ADDENDUM # 1

Solicitation #7549150

Title: Provide Site Improvements at the Knight Campus Baseball Field

Pre-Bid Questions, Response to Comments, and Concerns

REF DWG:	SKL-001	S-1
----------	---------	-----

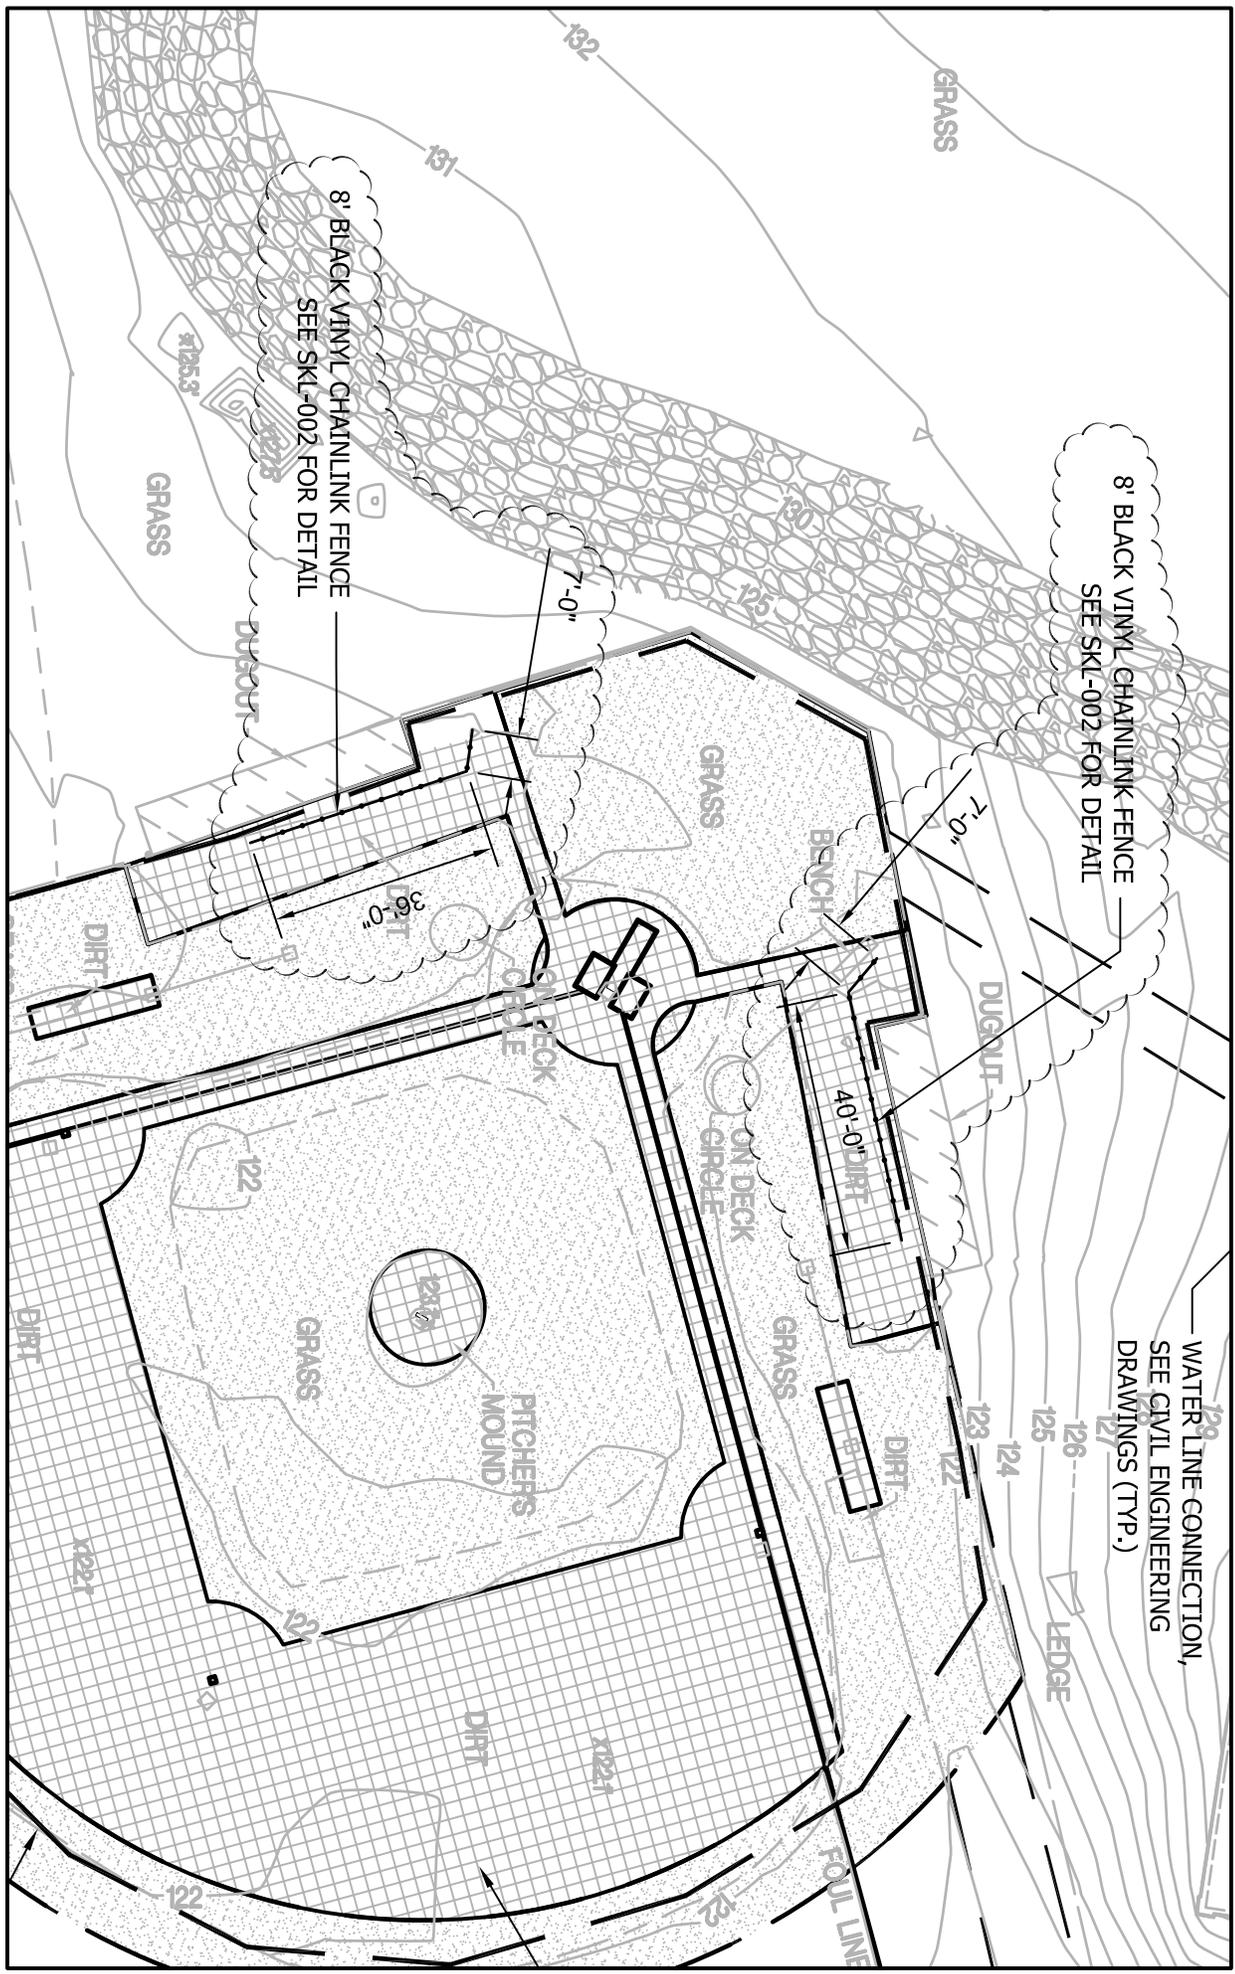
- 1.0 **ADD:** SKL-001 and SKL-002 which indicate new black vinyl chain link fence, posts and foundations directly in front of both dugouts as part of the scope of this contract.
- 2.0 **ADD:** SKL – 003 which indicates loam and seed in areas outside of baseball field fence.

REF DWG:	N/A
SKL-003

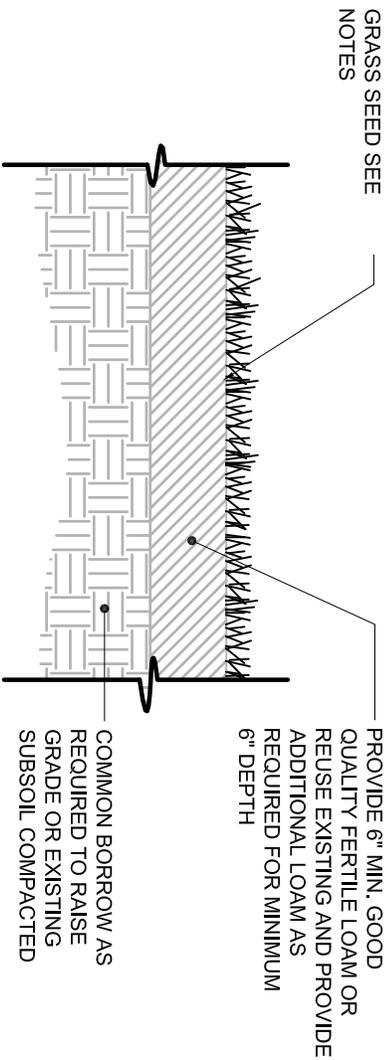
- 10.0 The documents indicate a detail for sod, can you clarify if this detail is to be used for all areas including areas outside of the baseball field fence.

Response: All disturbed areas inside of the baseball field fence will include the sod detail as provided on 6/LD-1. All areas outside of the fence will use the detail provided SKL-003 of this addendum.
